Service Bulletin

Model: D-121/125

No. 372

Subject: CD Not Locking - Reconnect CN501

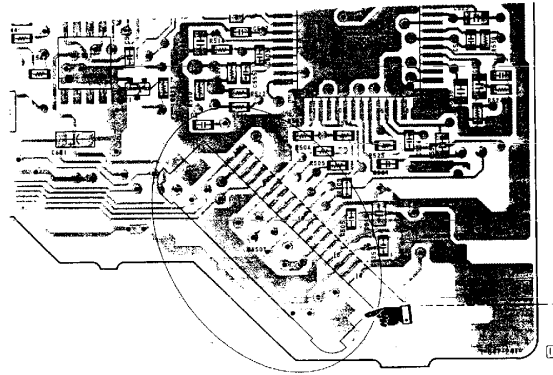
Symptom:
(12)

Unit would not read disc, indicating "No Disc" on display.

Solution: Reconnect connector CN501 onto Main Board.

REF	DESCRIPTION	PART NUMBER
CN501	CONNECTOR, FPC (ZIF) 18P	1-566-534-11
